PENNSYLVANIA  
**FISHPOND DAM**

NDS ID NO. PA-899  
DER ID NO. 19-81

PHASE I INSPECTION REPORT  
NATIONAL DAM INSPECTION PROGRAM

L. ROBERT KIMBALL & ASSOCIATES  
DACW31-80-C-0020

PROFILE  
LOOKING UPSTREAM  
(SCALE 1"=100')

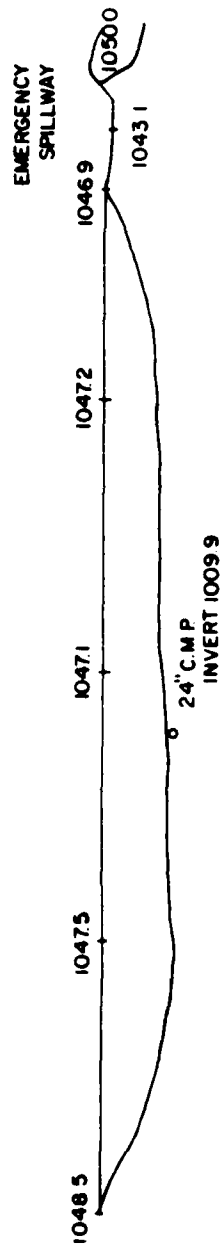
2. Raise the height of the earth berm to the right of the emergency spillway to a minimum of top of dam elevation (See page A-12).
